ADDENDUM #2

PROJECT: Thousand Islands Secondary School
HVAC Replacement & Upgrades
PROJ. NO.: 24078
DATE: April 29, 2026

DRAWING:
ELECTRICAL:
GROUND FLOOR PART 2 -
DEMOLITION

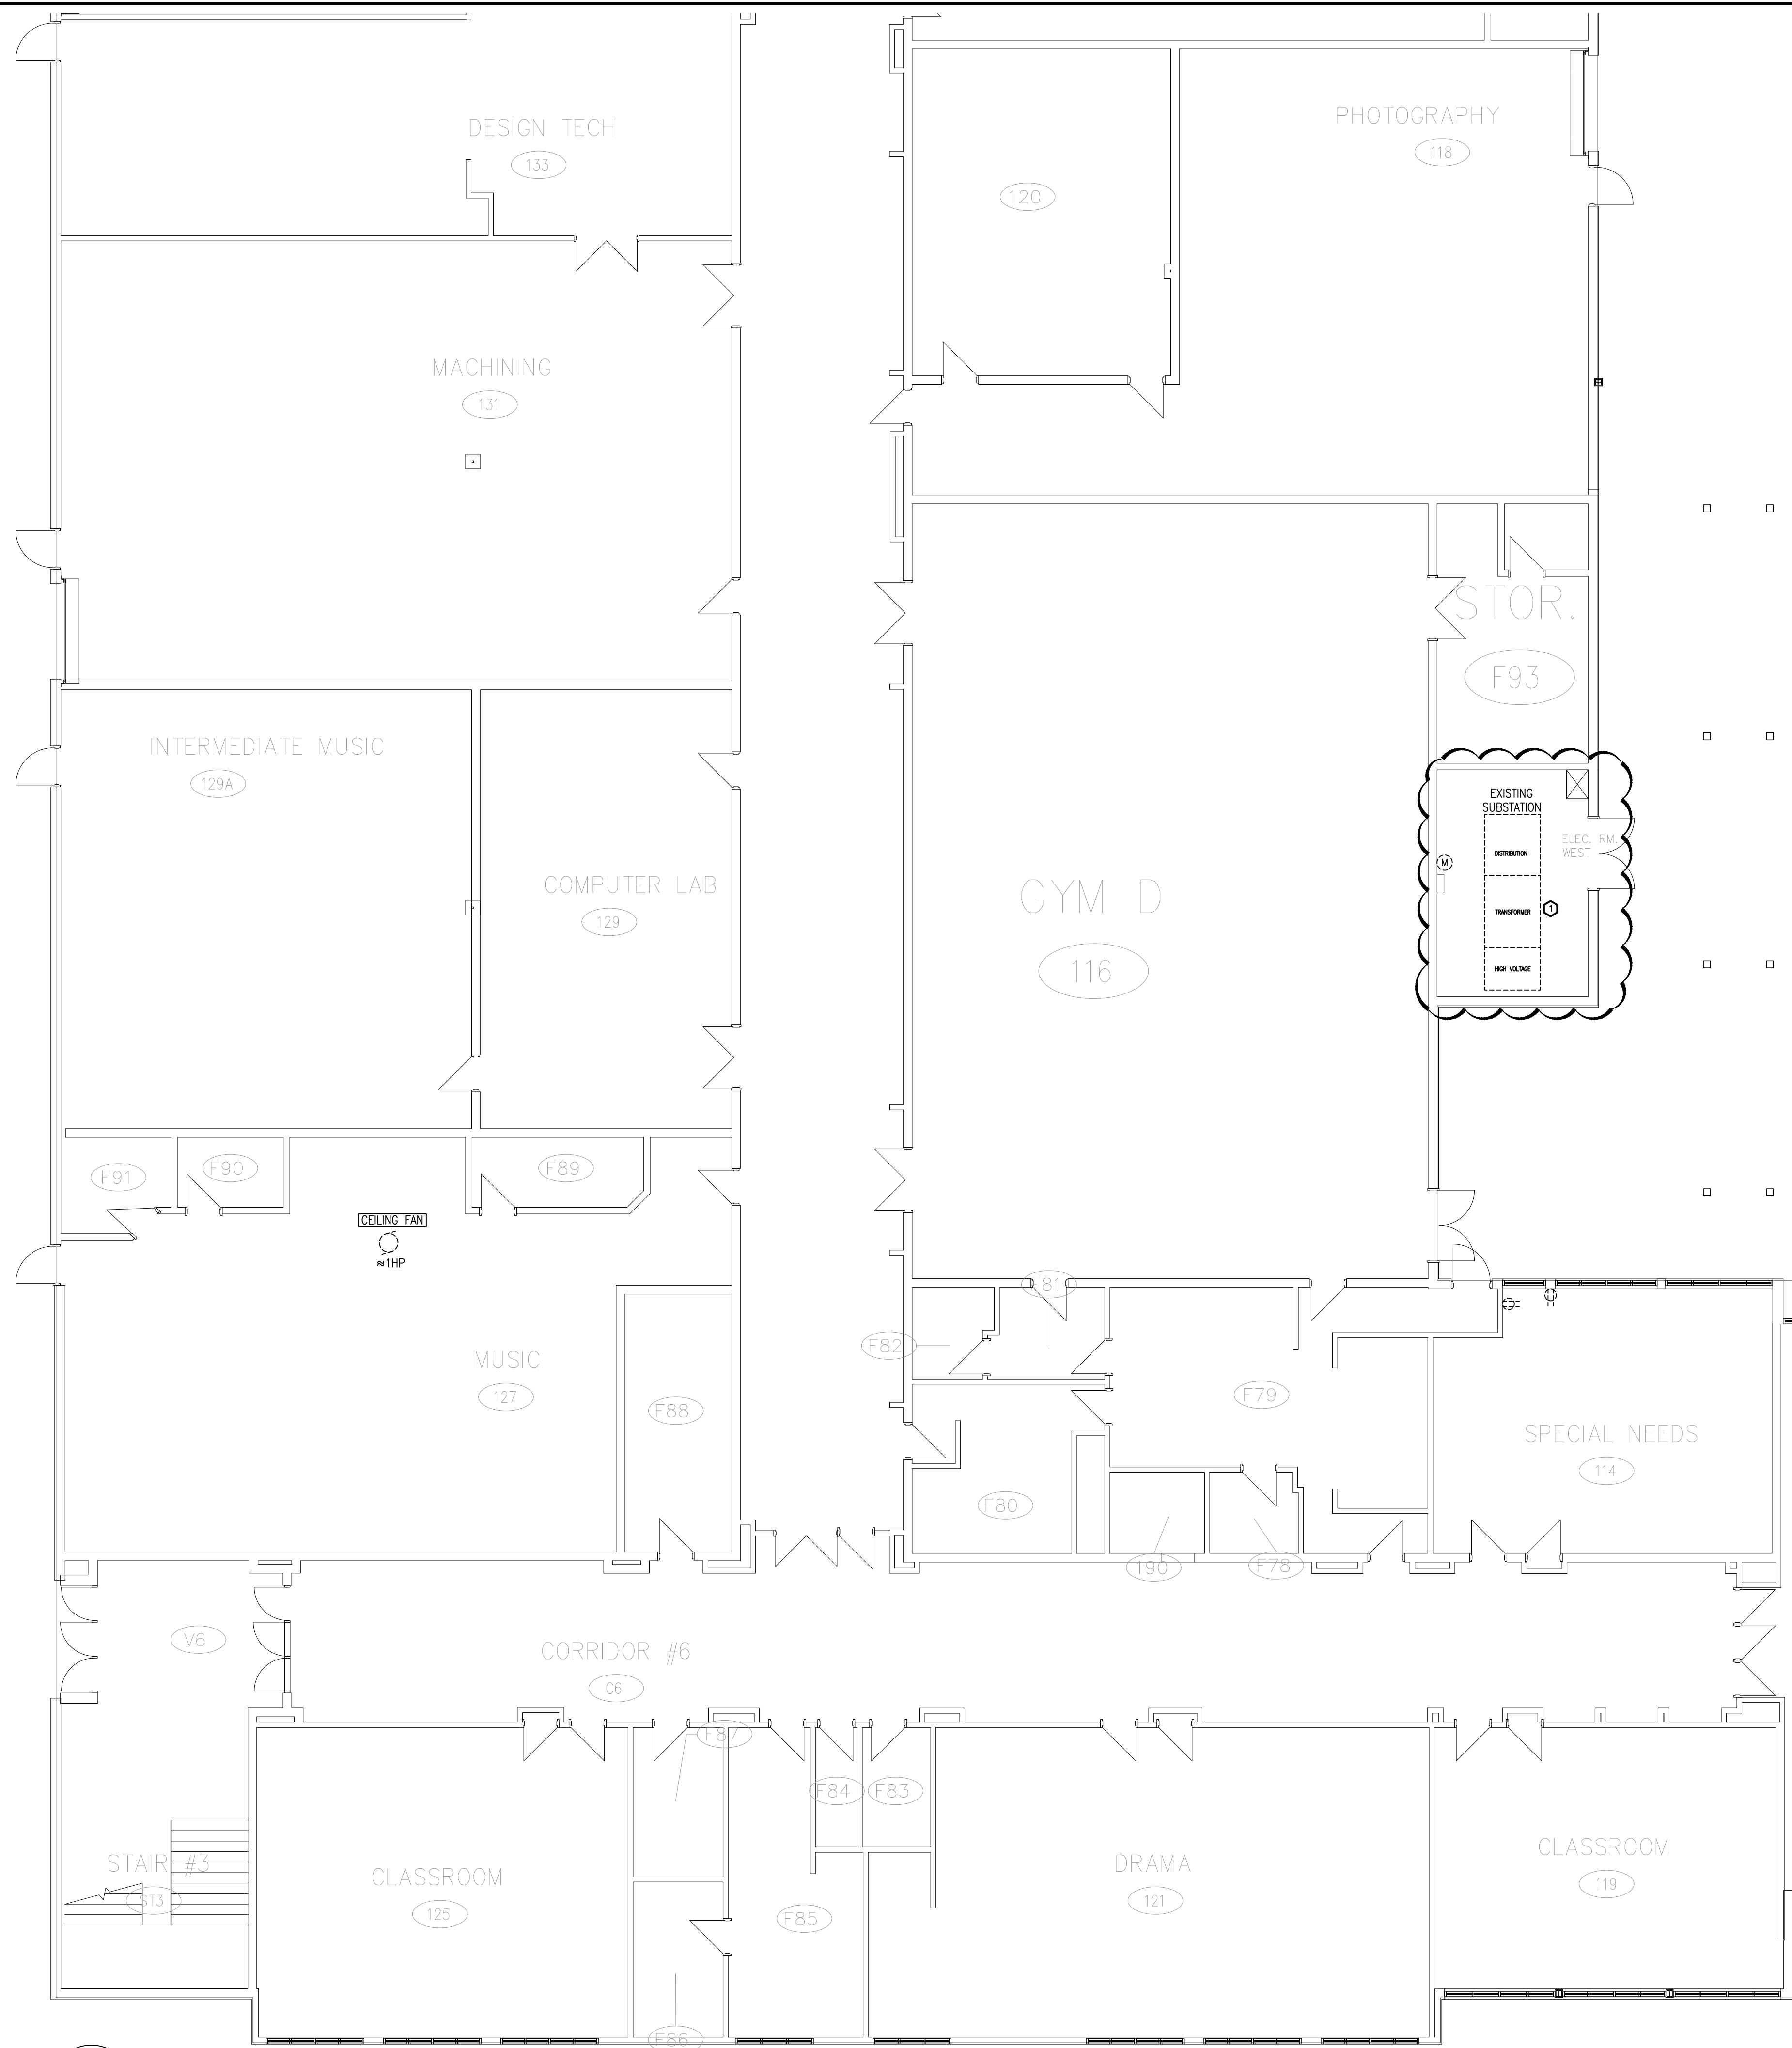
17. Q: It was brought up at the site meeting that floors in electrical rooms would need to be cut and broken up to expose feeder cables. This is not on any drawing - please clarify.
A: Refer to attached revised drawings for floor removals and reinstatement.

- 1 REMOVE EXISTING CONCRETE FLOOR AS REQUIRED TO EXPOSE EXISTING CONDUIT. PRIOR TO CONCRETE REMOVAL, CONTRACTOR SHALL SCAN THE SLAB TO LOCATE ALL EMBEDDED SERVICES. DISCONNECT AND PULL BACK EXISTING CONDUIT TO NEAREST PARTITION. SPlice EXISTING FEEDERS AND PROVIDE NEW WIRE AND CONDUIT TO MAIN SWITCHBOARD SHOWN ON THE NEW PLANS.

SCALE:
 1:100
 DRAWING No.
 SKM-ADDM002A
 JOB No.
 25020

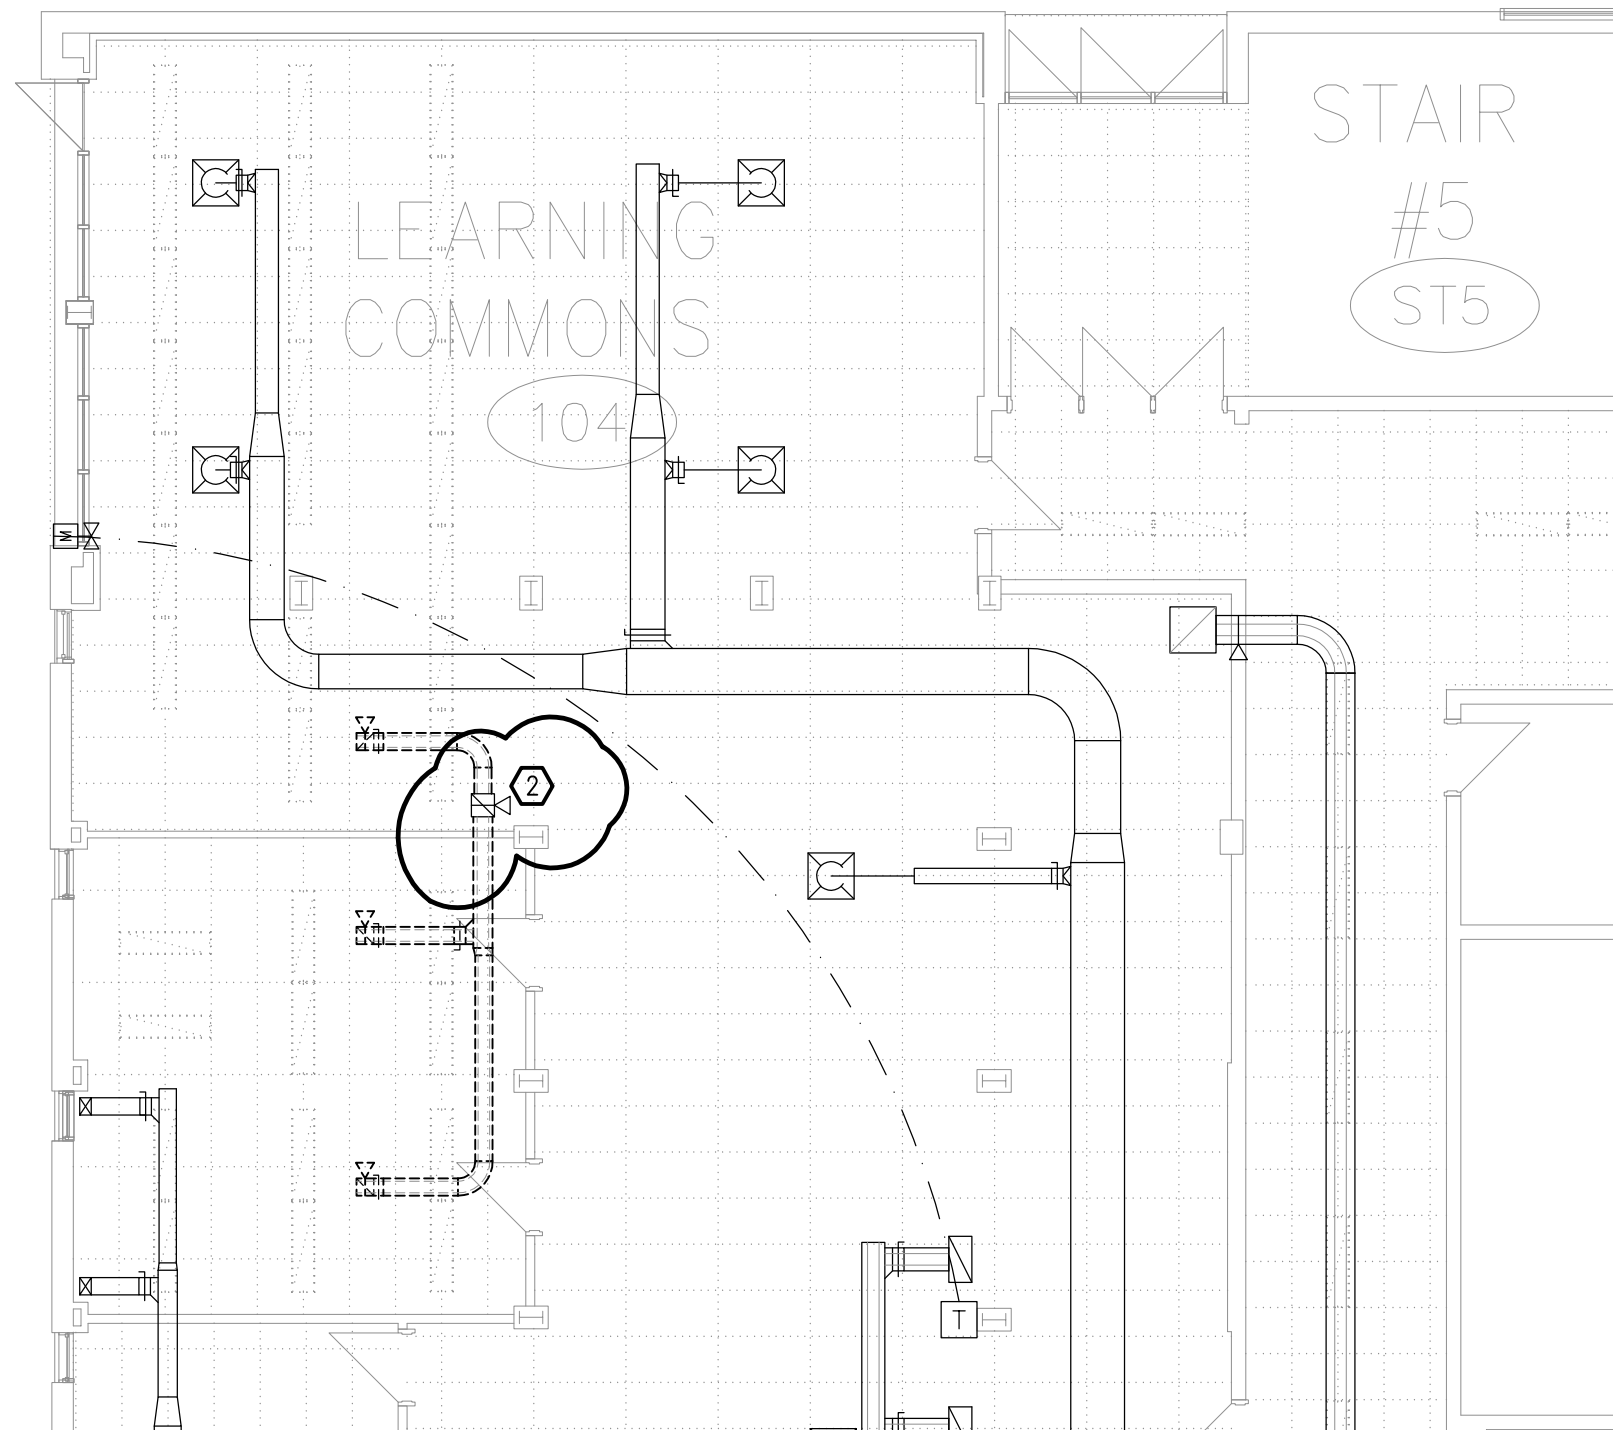
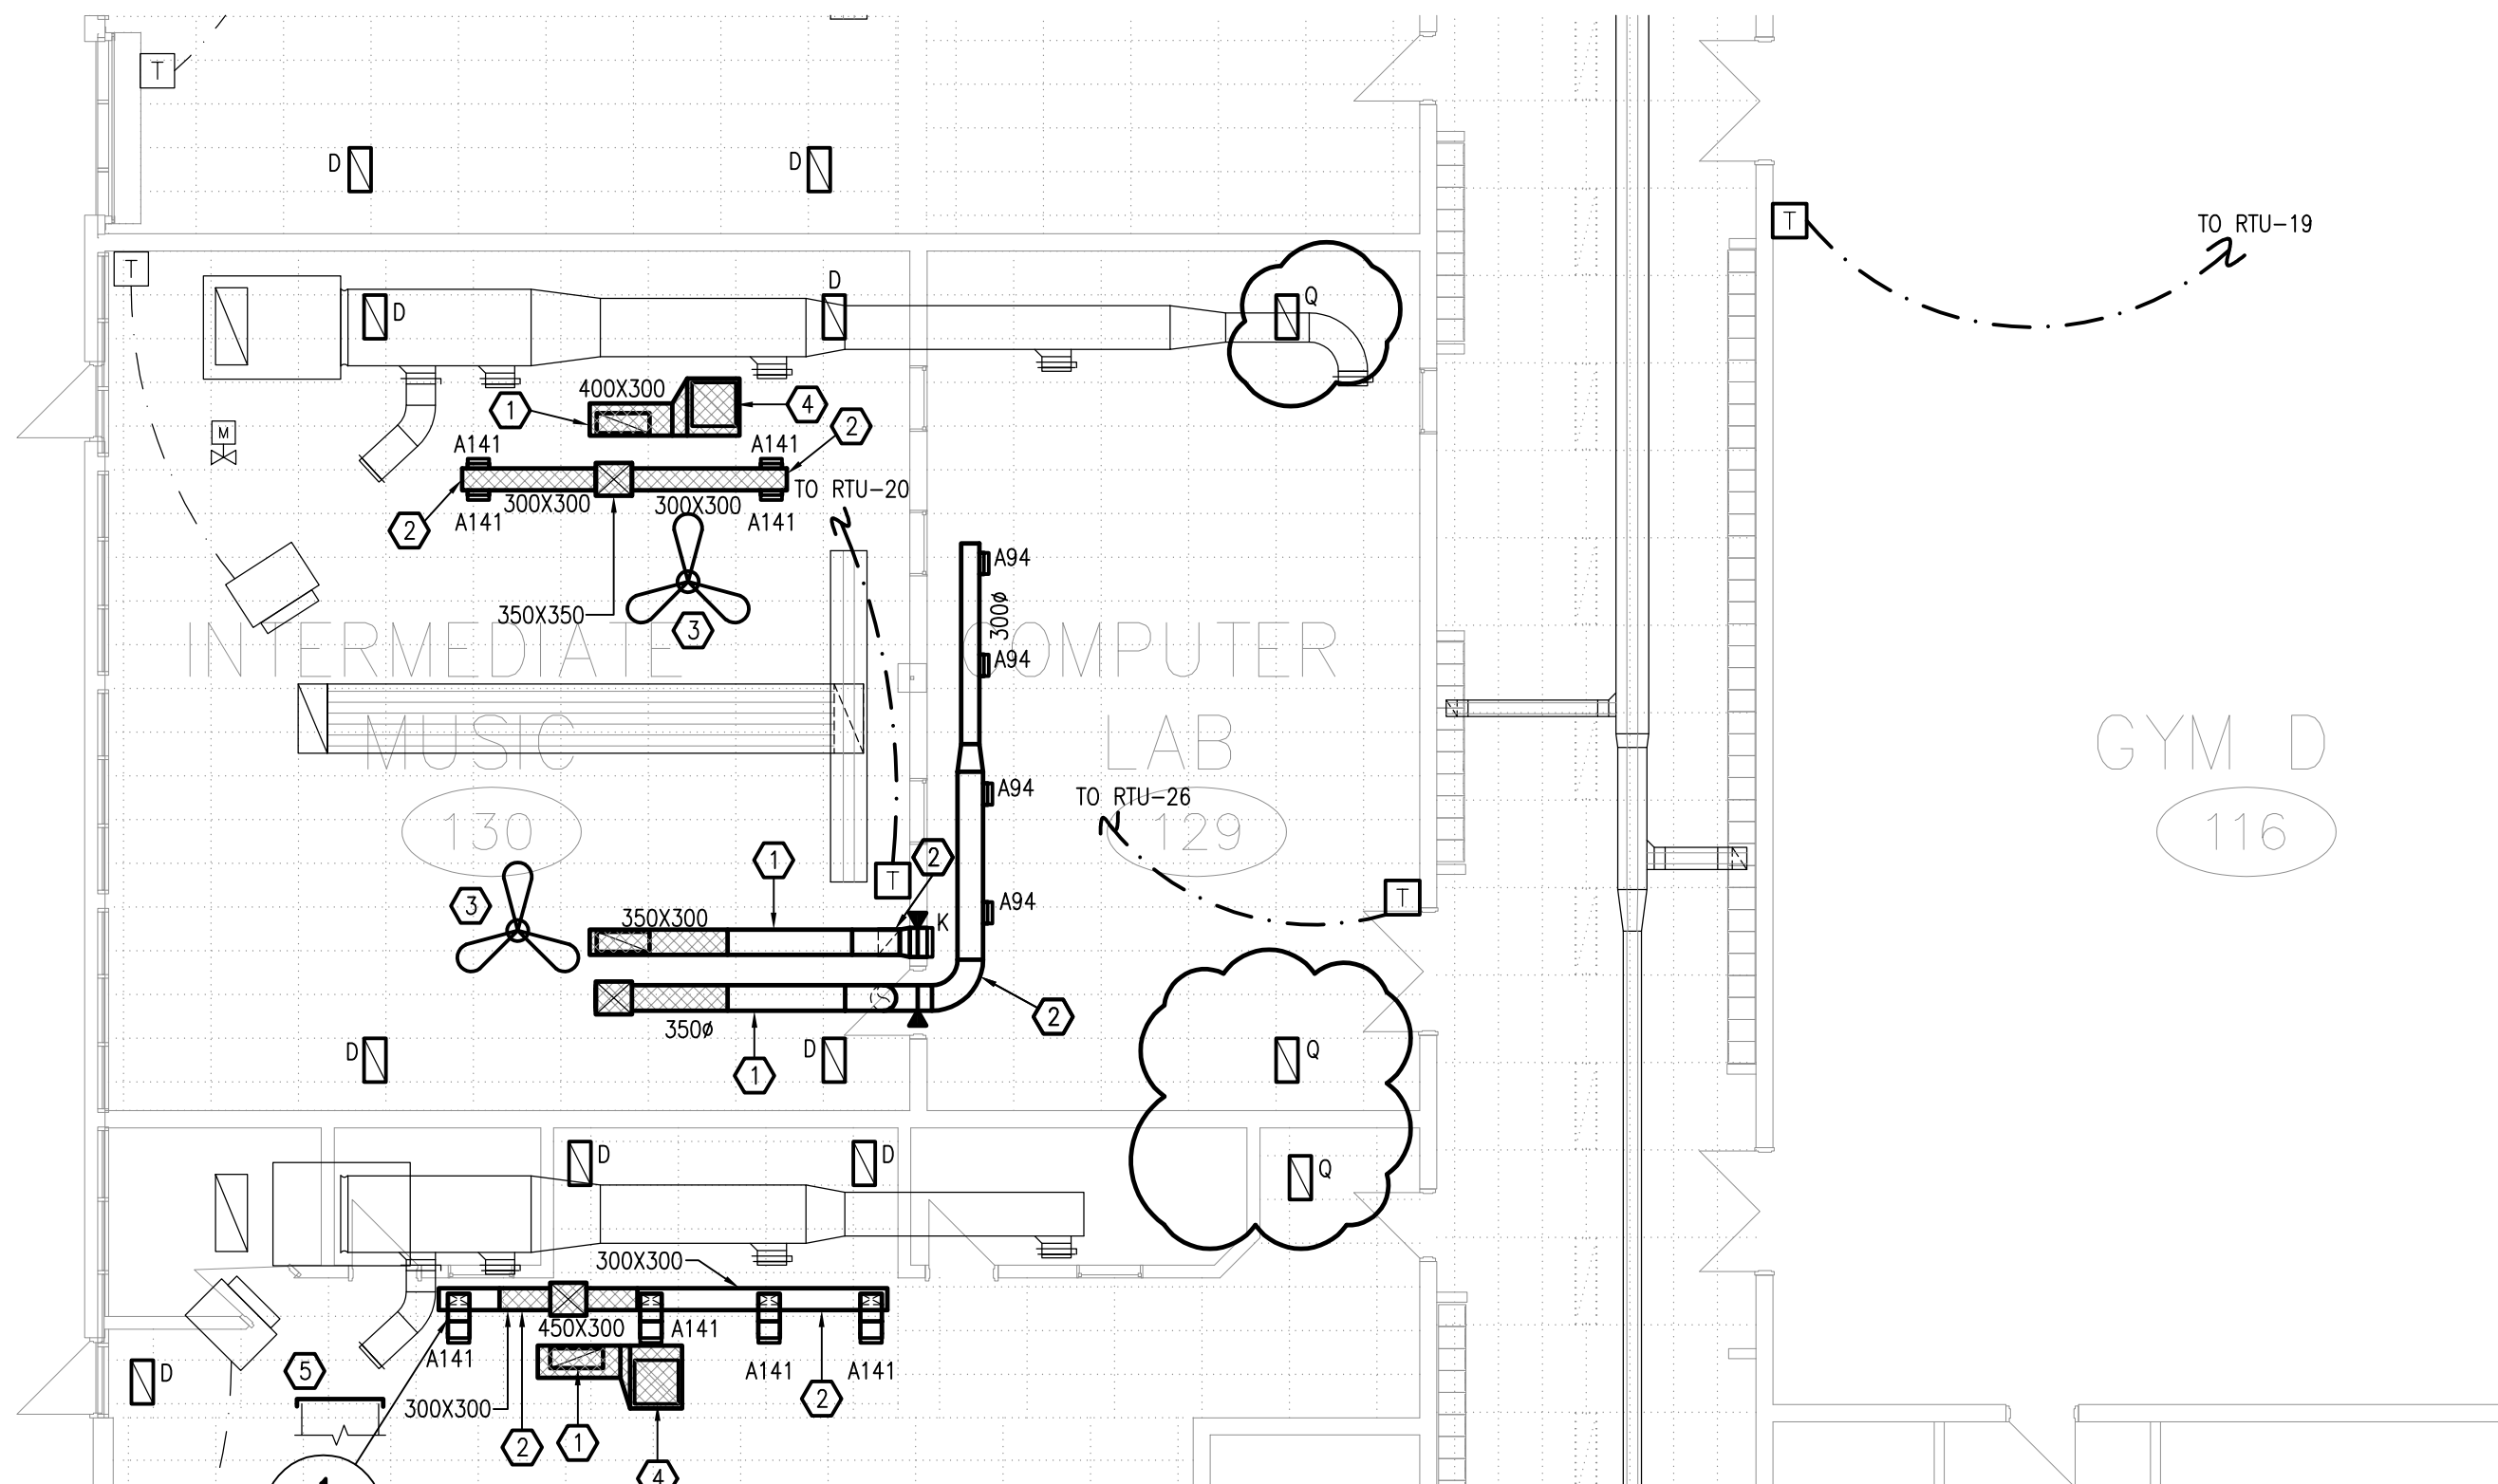
- .4 Revise design as per attached sketches SKM-ADDM002A to SKM-ADDM002E.

- ① CUT BACK AND REMOVE DUCTWORK AS INDICATED. CAP DUCT ON CORRIDOR SIDE AND CLOSE FIRE DAMPER. WALL GRILLES TO REMAIN.
- ② CUT BACK DUCTWORK AS INDICATED AND CLOSE FIRE DAMPER AT SECOND FLOOR SLAB AND CAP DUCTWORK BELOW SECOND FLOOR SLAB. ABANDON DUCTWORK WITHIN SHAFT.
